Service Bulletin

Maintenance of Way Equipment

Date: 10.15.2026**RRP Service Bulletin No:** RRP SB408**Title:** Inspect AAM Turntable Cylinder RRP# 472500 Welds**Rating:****ALERT**

Summary: Possible cracking/fatigue failure on the RRP# 472500 Turntable Cylinder Welds.

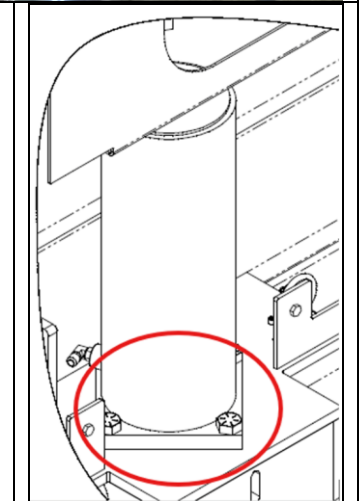
Action: Inspect the welds on the turntable cylinder RRP# 472500 between the mounting plate and cylinder body for cracking/fatigue failure (see drawing for location).

Completion / Resolution: If there is cracking / fatigue, replace the cylinder.

If there is no damage, continue with normal machine operation.

Check the welds annually for cracking and fatigue.
